PRODUCT CHANGE NOTIFICATION

Housing Material Changes for Bourns® 12 mm Potentiometers

Model PTV112 Series

SC2056

View of the finished product with original housing:

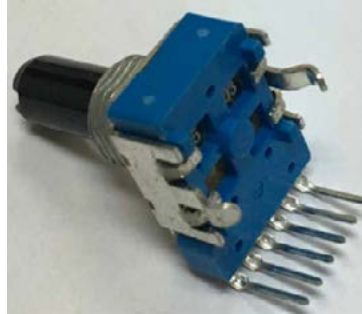
Current Housing	New Housing
<ol style="list-style-type: none"> 1. Substrate material: Phenolic resin board 2. Form of housing change 	<ol style="list-style-type: none"> 1. Substrate material: FR-4 2. Form of housing change: addition of support pins
Phenolic resin board	FR-4

The change will affect the form of the product, as support pins will be added to the housing as shown above. The quality and reliability of the product should improve. The fit and function will remain the same. A list of affected part numbers is included on the next page.
